**MEMORANDUM**

REVIEW TYPE: Site Plan

APPLYING FOR: 125,000 sf Office Space (Medical Office)
PROJECT NAME: Germantown Gateway
CASE #: 8-02010
REVIEW BASIS: Site Plan Review required in the C-T zone

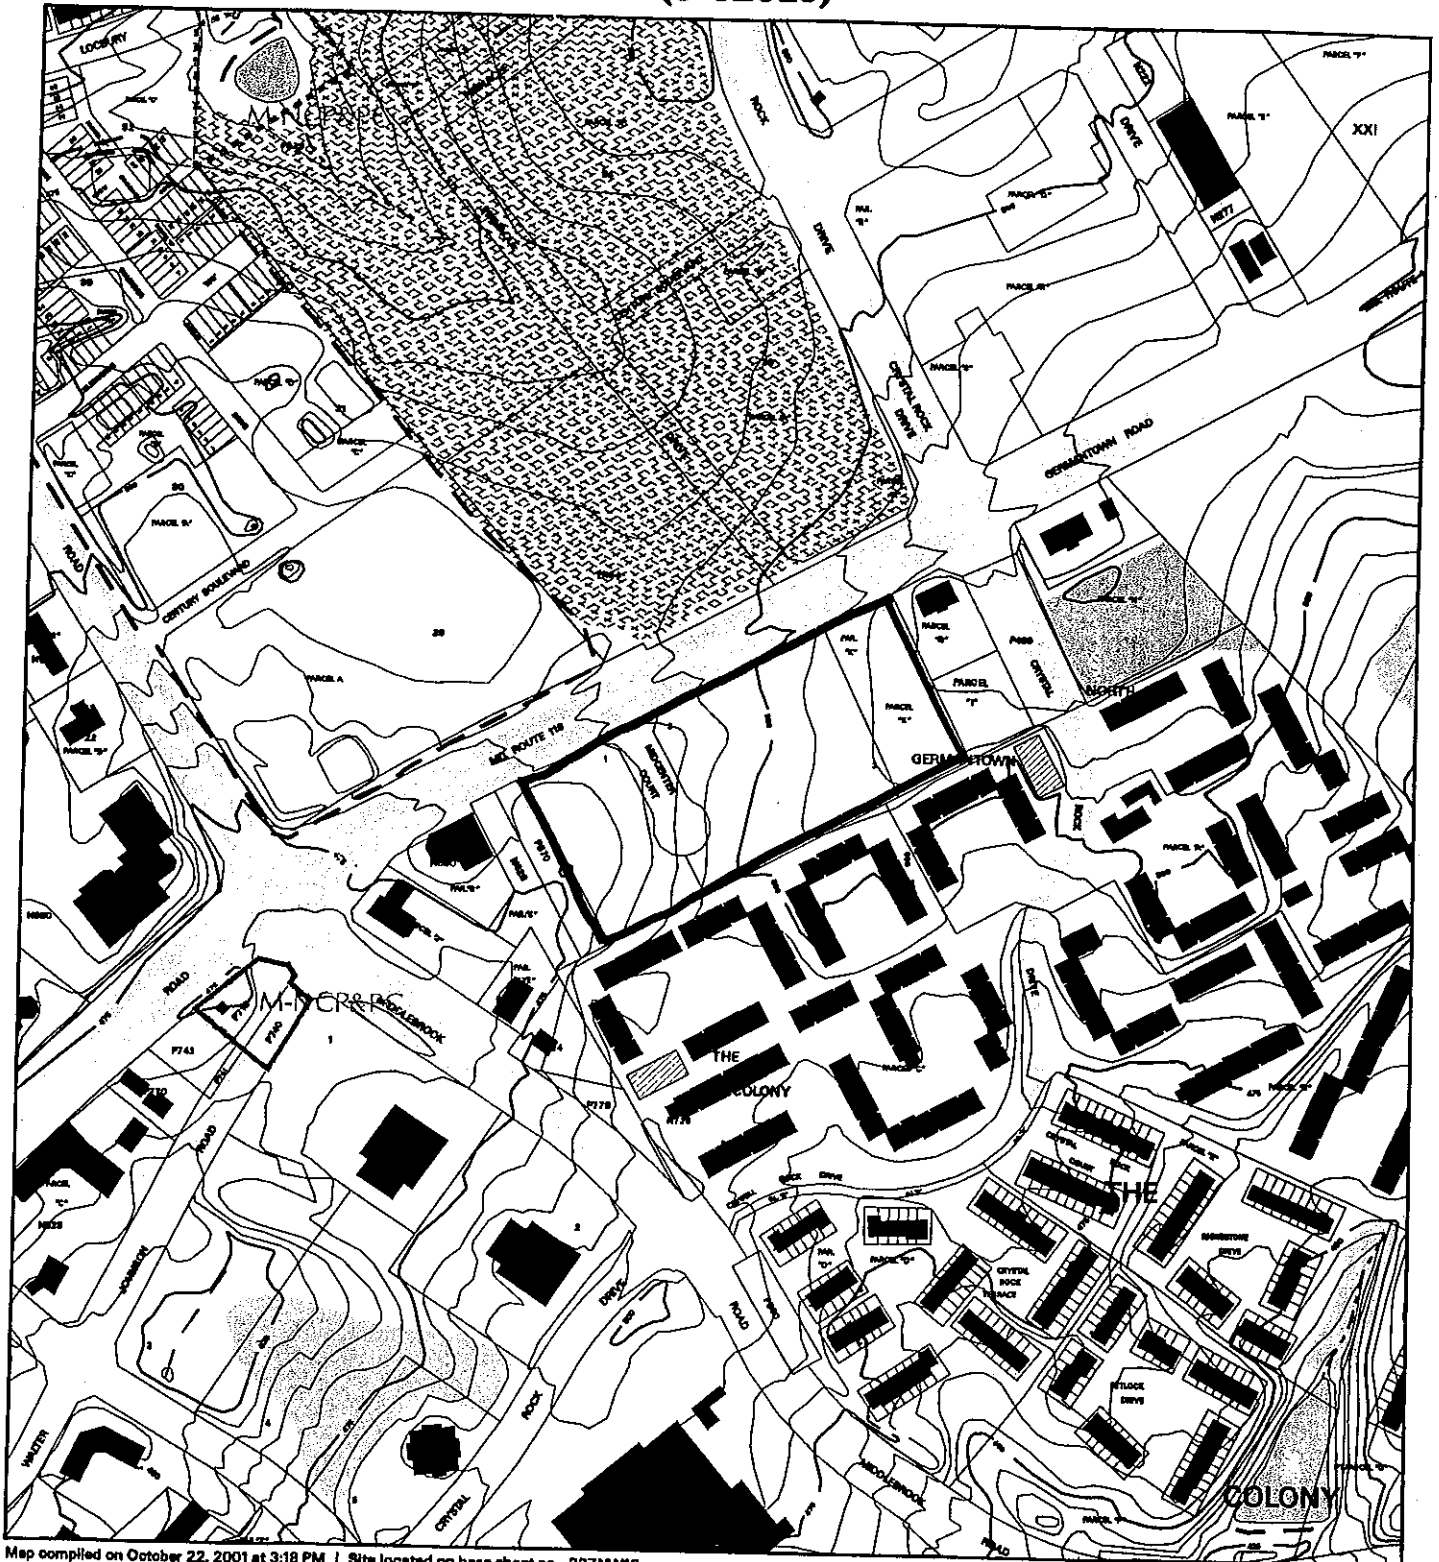
- a. Provide details of paving, furnishings and fixtures for entrance areas, and amenity areas;
- b. Provide one bicycle rack for each building;
- c. Provide sidewalks at 7 feet in width where sidewalk abuts curb;
- d. Provide details for tree protection on adjacent properties;
- e. Provide revised photometric lighting plan, using IESNA standards;
- f. Provide Class I shared use bikeway on the south side of MD 118, as per Preliminary Plan condition.

The open space is adequate, safe, and efficient. Staff recommends tree protection measures for the landscaping screen at the adjacent property to the south.
 - c. **Landscaping and Lighting**

Staff recommends a few additional trees within the parking lot and at the perimeter.
 - d. **Recreation**
